Appendix D
Mendocino Council of Governments
Covelo State Route 162 Corridor Multi-Purpose Trail
**Response to Comments and Errata on Initial Study/Mitigated
Negative Declaration**

December 2017

**Subject: Covelo State Route 162 Corridor Multi-Purpose Trail
 Initial Study and Proposed Mitigated Negative Declaration
 SCH# 2017102051**

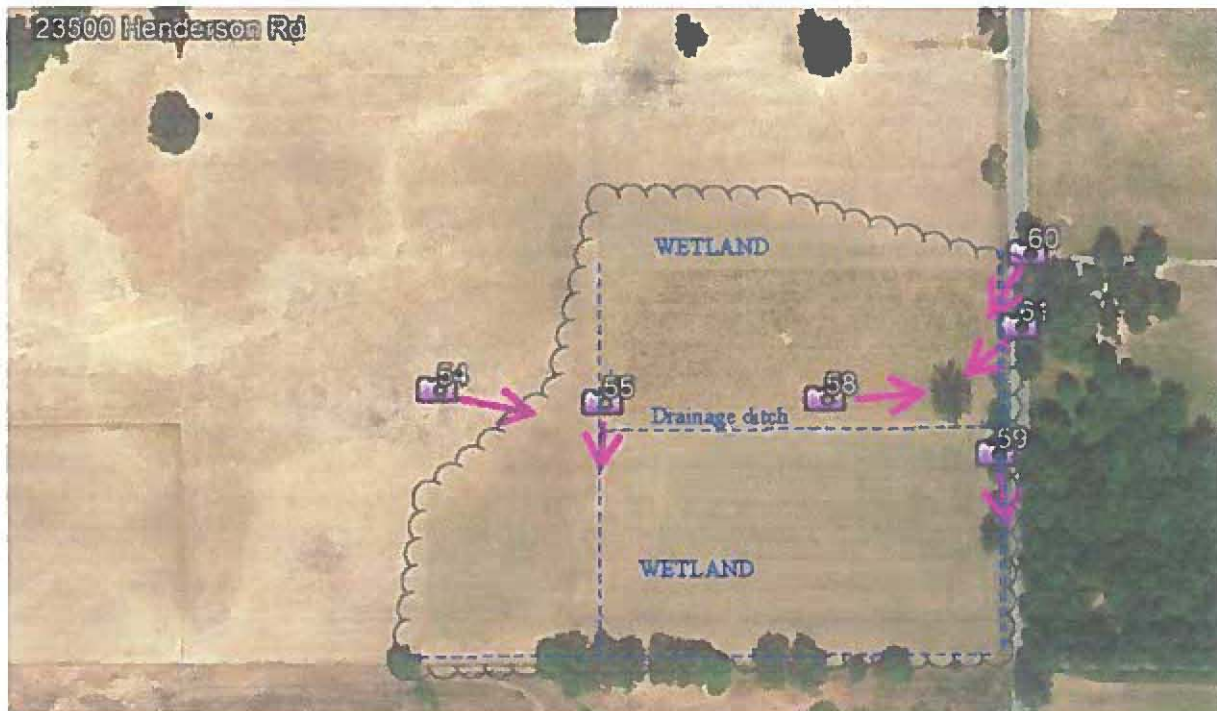
Below is a Google Earth image of your property west of Route 162 on which the trail is proposed to be built. The image shows the point of views of photographs taken during my visit and a general outline of the wetland area. North is up the page. The photograph numbers have no inherent meaning. Note the contrast in ground color/texture between the wetland and the surrounding area.

Based on my observations, and photographs of the area taken during the rainy season that you provided, I believe the area to be crossed by the multi-purpose trail is indeed a wetland. The photographs are presented below with each followed by a discussion of what the photograph shows that identifies the area as a wetland.

This is an introductory comment from the McEdwards Group letter. The comments identify when the site was visited, an assertion that a "wetland" is located within the State Route (SR 162) right-of-way (ROW). Also included is a Google Earth image showing the location of where the photographs were taken and general outline of the "wetland area" as determined by the McEdwards Group. Based on the information provided, it does not appear that the McEdwards Group opinion regarding wetlands is based on U.S. Army Corps of Engineers (USACE) wetland delineation standards for jurisdictional determination.

As noted in the ISMND, a wetland delineation, based on the USACE three-parameter approach, was conducted in May and June, 2017 for the project Alternative 1 alignment. The Dewey-White parcel was not included in its entirety because permission to enter the property was not received. However, wetlands were identified along the SR 162 road ROW. The wetland delineation identifies the Palustrine Emergent Ditch on the west side of SR 162 through the Dewey-White parcel. MCOG sent a wetlands jurisdictional determination (JD) request letter in July, 2017 to request a JD from the USACE. A section 404 permit would also be obtained from the USACE for this project and would take place after the CEQA process. Mitigation Measure BIO-6 is included to mitigate direct and temporary impacts to wetlands. Reference Section 3.4 (c) for a discussion of wetlands, Mitigation Measure BIO-6 for wetlands mitigation, and Appendix C for the wetland delineation figures.

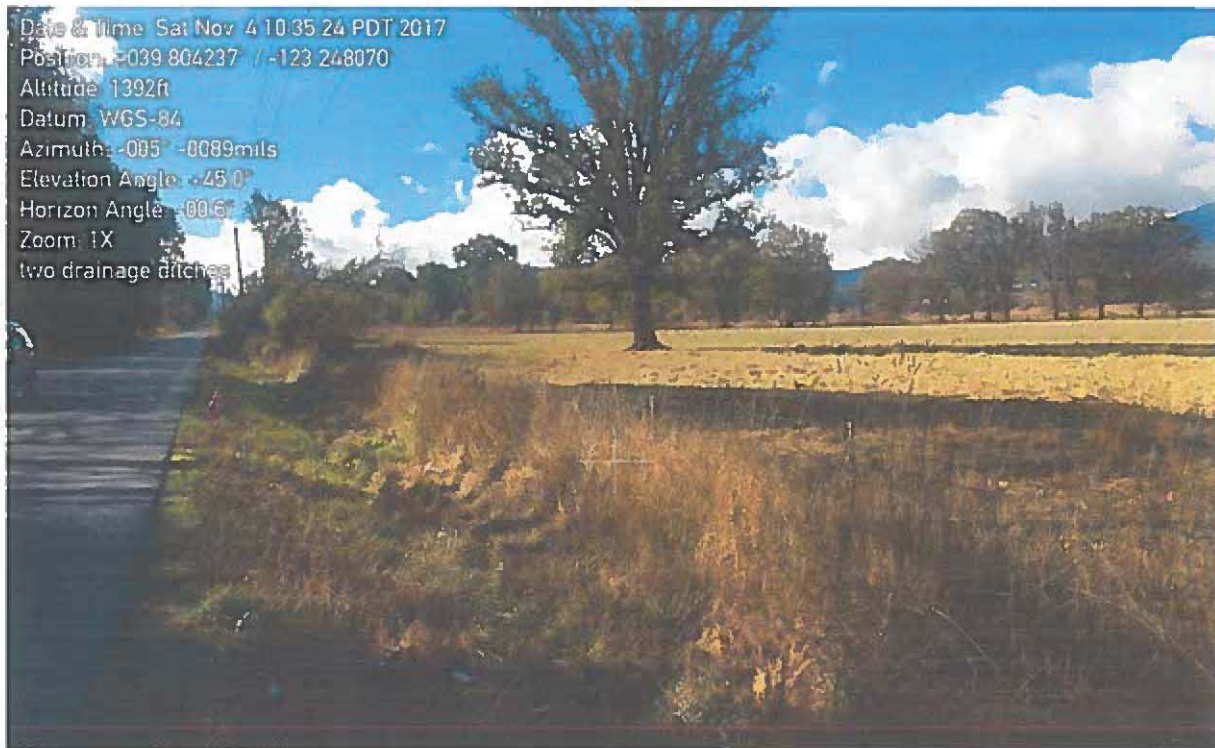
The locations of the two north-south and two east-west old drainage ditches are shown in the Google Earth image. The previous property owners would not have constructed these ditches in this specific area unless the area needed to be drained for economical use.

Image 60 looking southwest: Two drainage ditches are shown. The ditch near the road drains the roadway and the ditch on the left drains the wetland. Note the texture/color of the wetland area beyond the tree.

Image 61 looking southwest: Another view of the smooth texture of the wetland.
